# DRAFT TECHNICAL REVIEW REPORT FOR THE LUANG PRABANG HYDROPOWER PROJECT – DAM SAFETY

THE 9<sup>TH</sup> MRC REGIONAL STAKEHOLDER FORUM

DAY 1: THE 2<sup>ND</sup> REGIONAL INFORMATION SHARING ON PRIOR CONSULTATION FOR LUANG PRABANG  
HYDROPOWER PROJECT

05 FEBRUARY 2020, LUANG PRABANG, LAO PDR

### Reliability

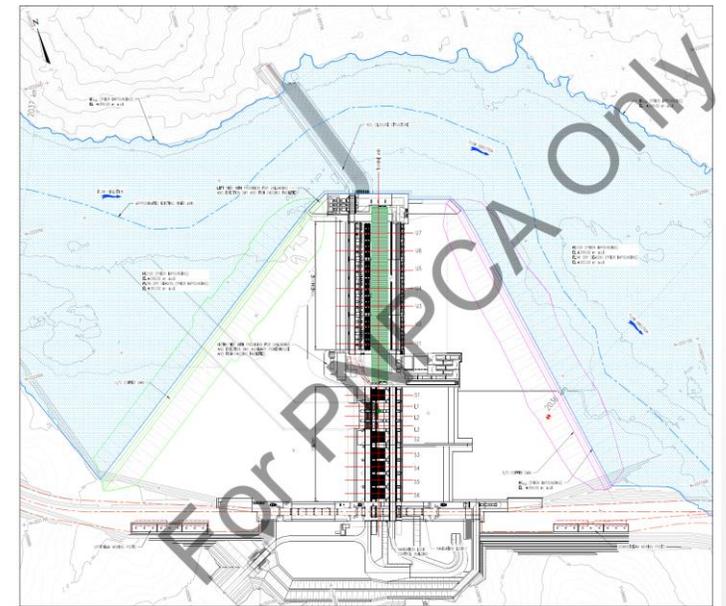
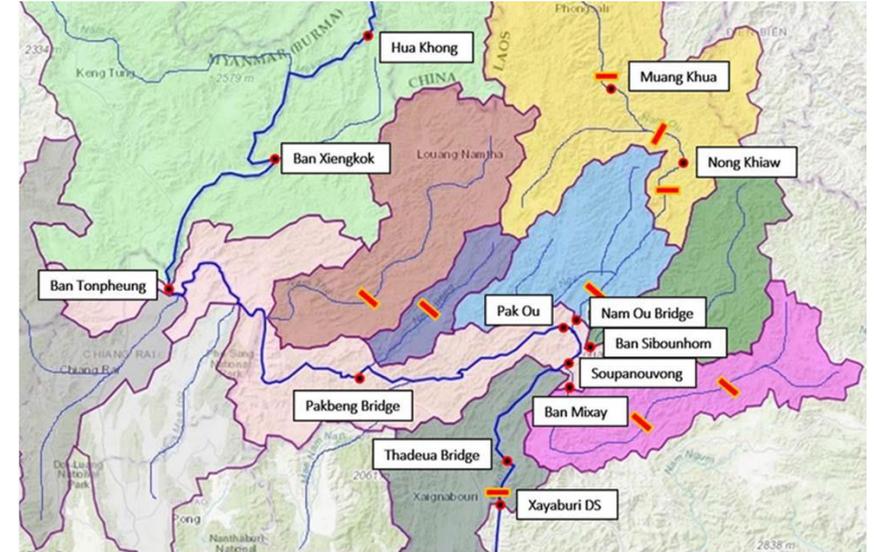
- The requirements for opening times, redundancy and security of spillway gate operation are **currently not considered in the FS report.**

## 2. Main Review Findings (5) – Reservoir Operations

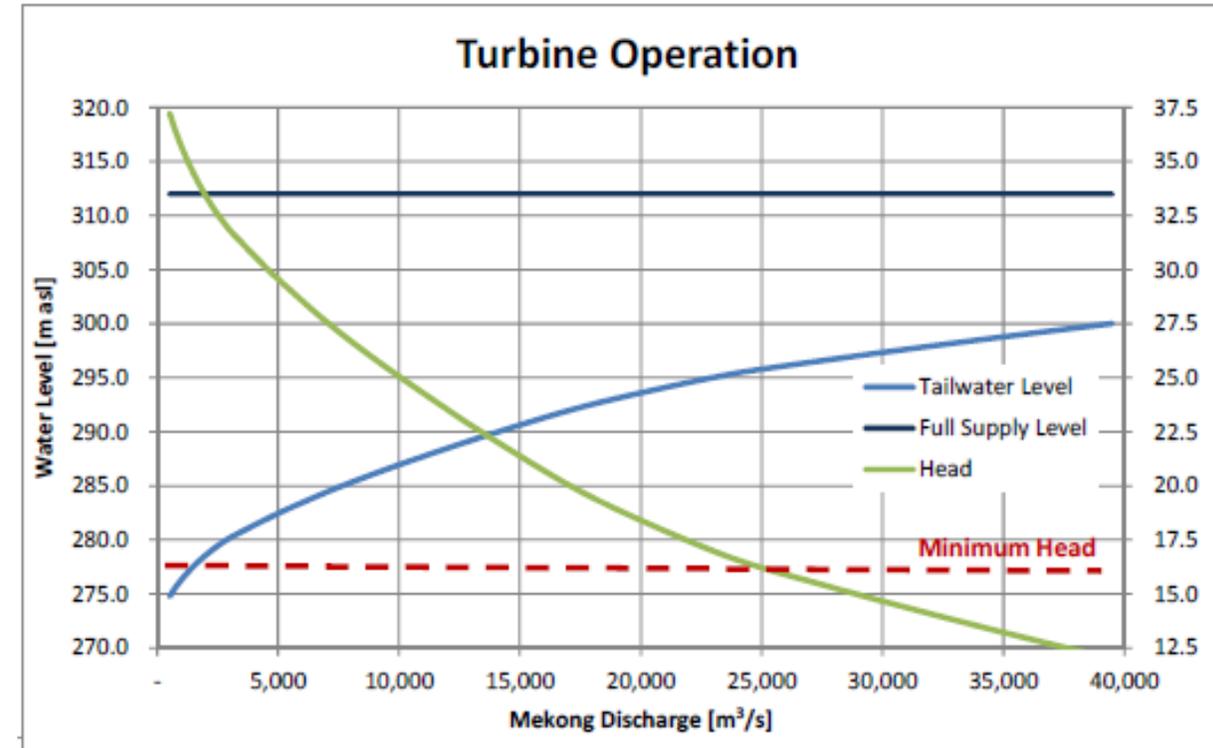
- The reservoir operating rules are not outlined in detail elsewhere in this FS report.
  - Require to limit the rate of change of water level D/S of HPP to a safe rate for riverbank users including river crafts
  - **NEED:** Ideally be considered and explored as part of the cascade operations.
- The operating level range of 312 to 312.5 m is higher than the value of 310 m proposed by GoL.
  - No apparent dam safety consequences for the adoption of this higher operating level. However, the impact is on the profitability of Pak Beng HPP.
  - **Must be resolved by GoL**

# Main review findings (7) – Failure Modes Assessment

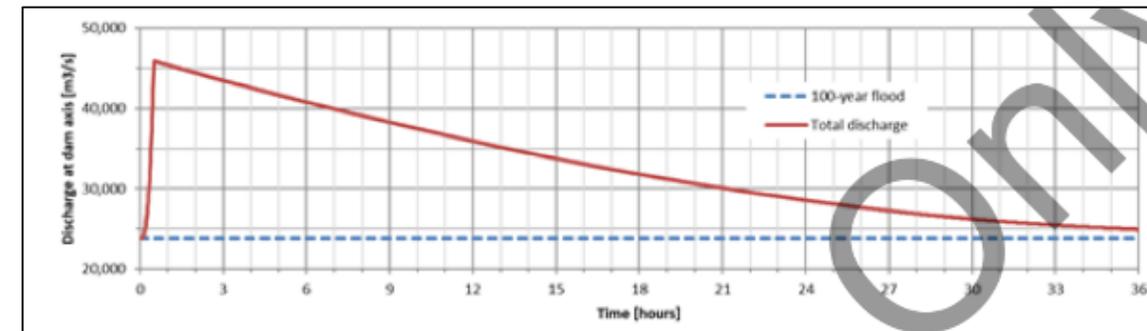
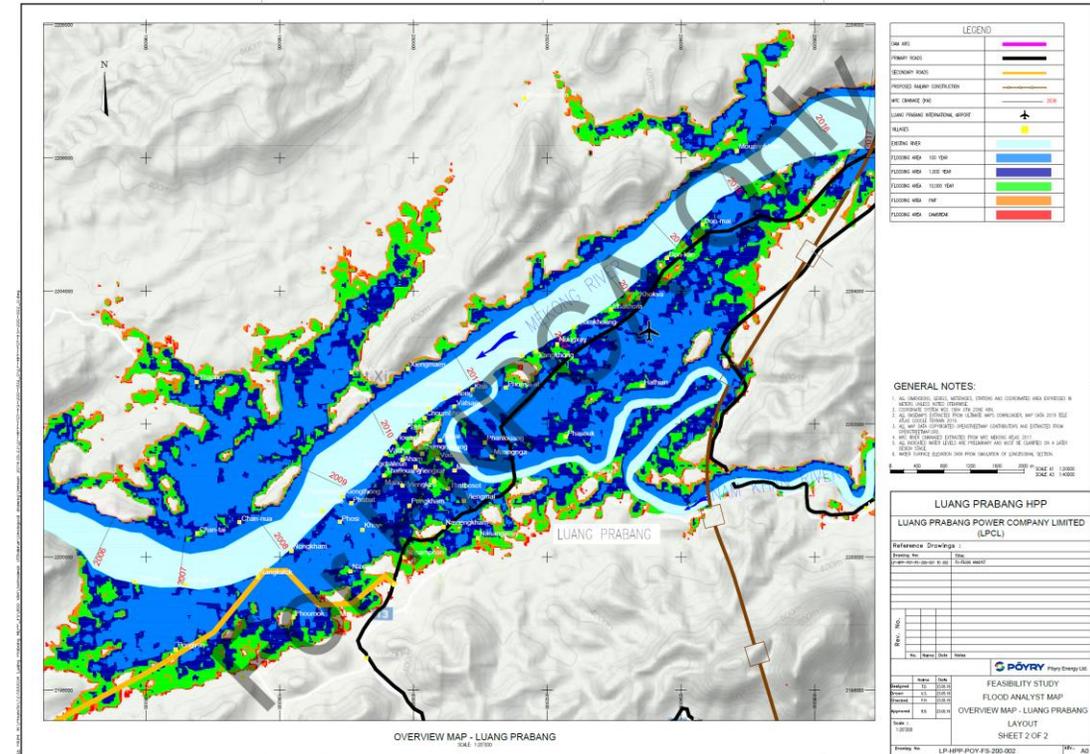
- The FS report presents an overview of failure modes assessment.
  - This is reasonable at this stage, but a detailed failure modes assessment should be undertaken at the commencement of the detailed design stage.
- The DS impacts of failure have been examined by the inundation studies in the FS.
  - At this stage sufficient work has been done, in the next stage, the potential for dam breach to impact Thailand should be checked considering together with other D/S projects e.g. Xayaburi.
